SLR Project No.: 402.V08525.00024

RE: Planning Application 25/00228/FUL Land North of Cut Lane, Kirkby

Background

Table A: BS4142 Results at Night - dBA

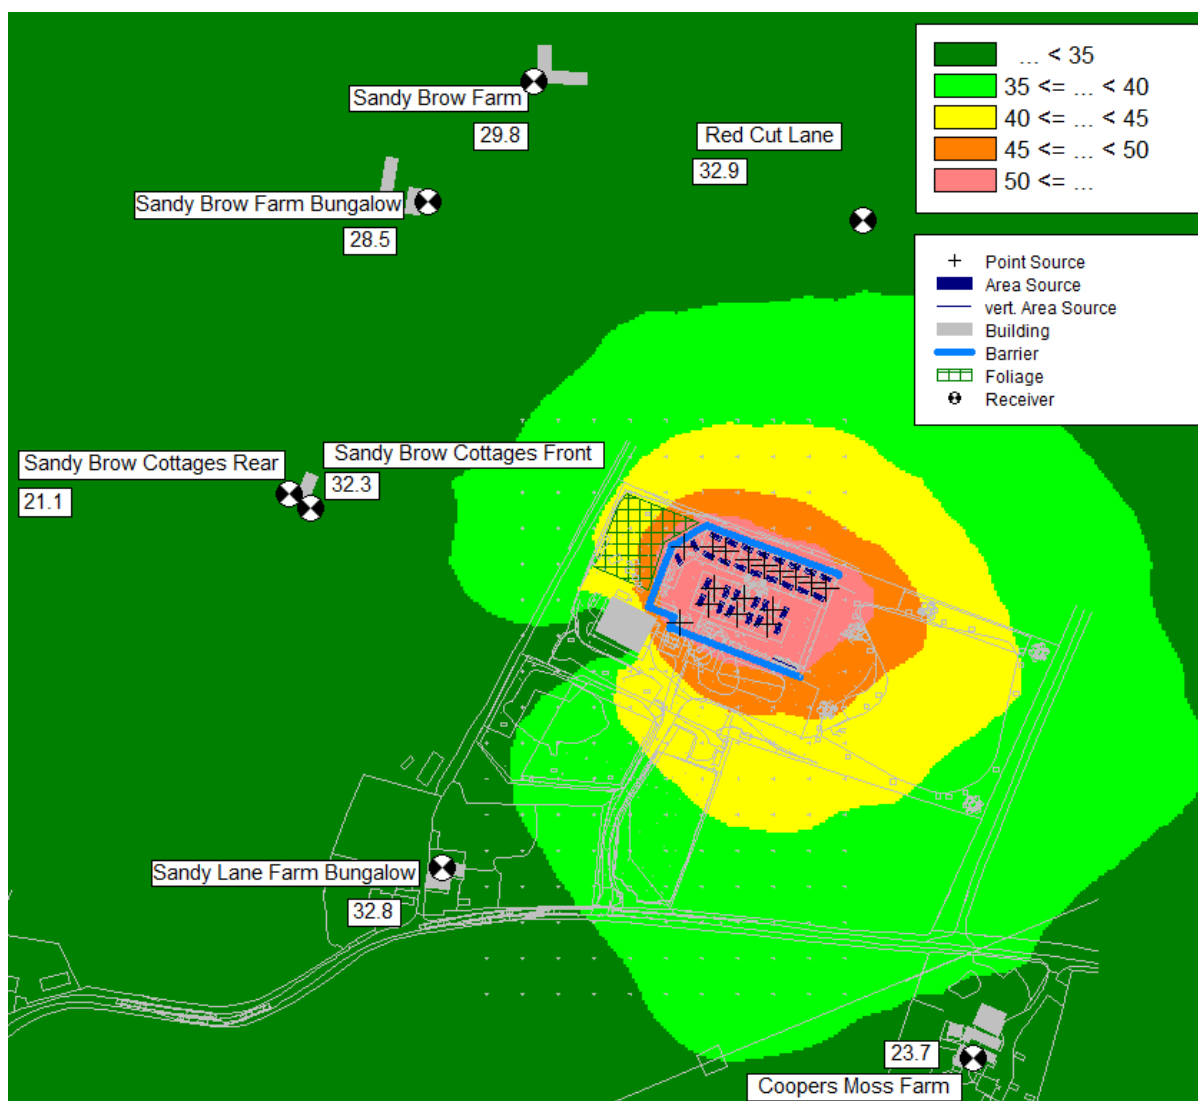
“Under BS 4142, in which the noise assessment for the site is based, the predicted +6 dB exceedance clearly indicates an adverse impact.

Environmental Health do not believe that the contextual arguments presented by SLR constitute valid grounds to dismiss the predicted outcome. Given the quiet rural context, night-time operation, and proximity of receptors, the risk of audibility, complaint, and potential statutory nuisance remains credible.

Reference to BS 8233 is not relevant within the BS 4142 framework. BS 8233 looks at general environmental noise, such as road traffic and internal comfort levels, not the assessment of distinct industrial noise.

We do not agree with the reliance on the 1.3 dB increase argument, we do not believe the method used to derive this figure is an appropriate measure under BS 4142. The ear can detect contrast in character and steadiness of sound, not only changes in the overall LAeq, and BS 4142 assesses the rating level relative to the background to capture this perceptibility. Therefore, in a quiet night-time environment, even a small increase in total LAeq, such as a steady mechanical noise 6 dB above background, could be distinctly noticeable.

Given the development, as assessed, is likely to result in at least an adverse impact under BS 4142 and no further mitigation can be put in place, it may be that the site is not suitable for such a development, therefore we object to the application.

We do not agree with accepting a proposed condition ‘that would limit the rating level from the Site to no more than 5dBA above the baseline background sound level’.”

Red Cut Lane is included in Figure A but it has not been included in the assessment as upon review of the land use at this parcel of land, there is no residential occupation identified.

In response to the above Pivot EDF has looked to re-design the layout of the Site so that the MVS units are shielded within the site by the BESS Units. The eastern barrier has also been removed as this fence was not affording any protection and was causing reflected sound to elevate noise levels to the west.

The results for the re-design at night are shown in Table A below. The proposed vegetation to the west has also been included.

For information, at the most affected receptor, Sandy Brow Cottages, both the façade facing, and the façade facing away, have been included in the assessment. It is assumed that both facades may have bedrooms.

NSR	Period	Specific	Predicted Rating Level, $L_{Ar,Tr}$ (dB)	Representative $L_{A90,15min}$, dB	Difference
Coopers Moss Farm	Night	24	27	34	-7
Sandy Lane Farm Bungalow	Night	33	36	34	+2
Sandy Brow Cottages Front	Night	32	35	31	+4
Sandy Brow Cottages Rear	Night	21	24	31	-7
Sandy Brow Farm	Night	30	33	31	+2
Sandy Brow Farm Bungalow	Night	29	32	31	+1

This re-design has enabled a 2dBA reduction at the most effected receptor Sandy Brow Cottages (compared to the previous layout). This has resulted in a rating level of no more than 35dBA.

Furthermore, the impact at Sandy Brow Cottages at night must be considered in context that the property has rear facing rooms that may be bedrooms. At the rear of the property, the rating level is 7dBA below the baseline background sound level.

The low rating level at the front of the property, and the rating level significantly below the baseline background sound level to the rear, support the view that the impact at night is low and acceptable.
